REQUEST

Current Zoning: R-MH LWPA LLWPA (residential manufactured housing, Lake Wylie Protected Area, Lower Lake Wylie Protected Area)
Proposed Zoning: I-2(CD) LWPA LLWPA (general industrial, conditional, Lake Wylie Protected Area, Lower Lake Wylie Protected Area)

SUMMARY OF PETITION

The petition proposes to rezone site to I-2(CD) to develop the site for off-site parking and outdoor storage.

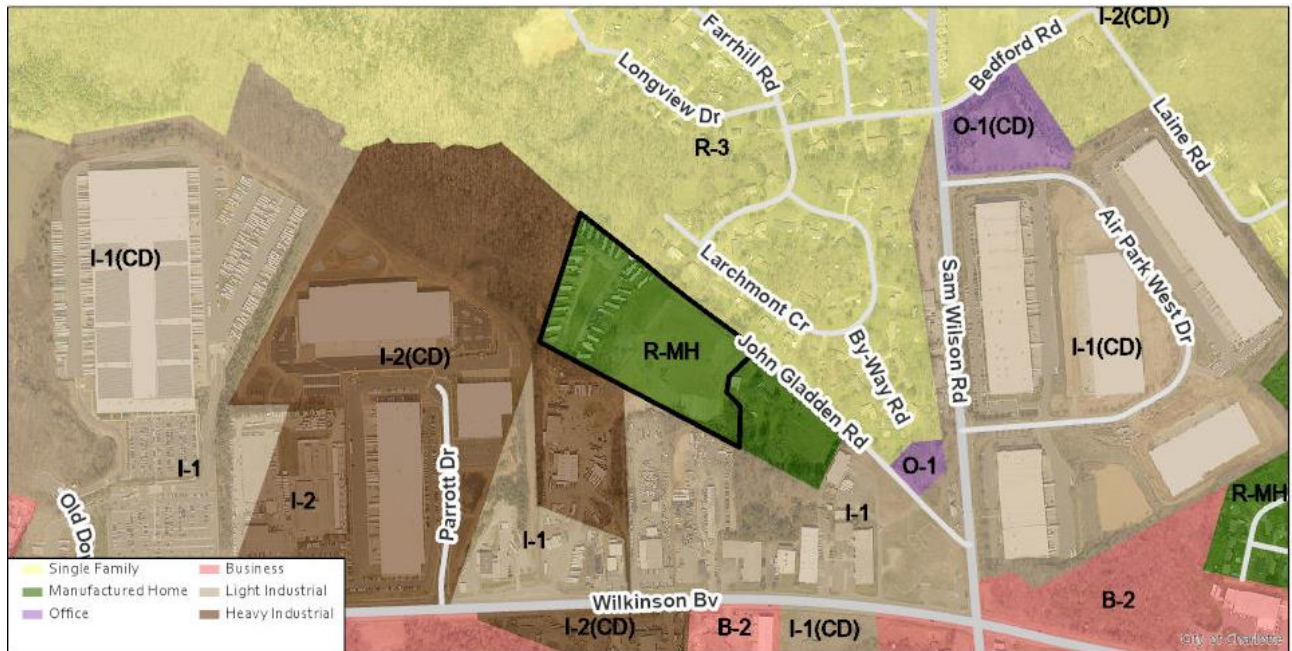
- ~~1. Will need to show required future buffer adjacent to R-3 single family in Development Area A.~~

- ~~2. The petitioner should revise the site plan and conditional notes, in reference to Sections 3.A. and 3.B, to establish and record a cross access easement across Tax Parcel Nos. 053-211-07 and 053-211-10 to Wilkinson Boulevard. Access agreement for all three parcels in the event that one or more parcel(s) is sold to another individual/entity for access to be maintained to Wilkinson.~~

ADDRESSED

ADDRESSED
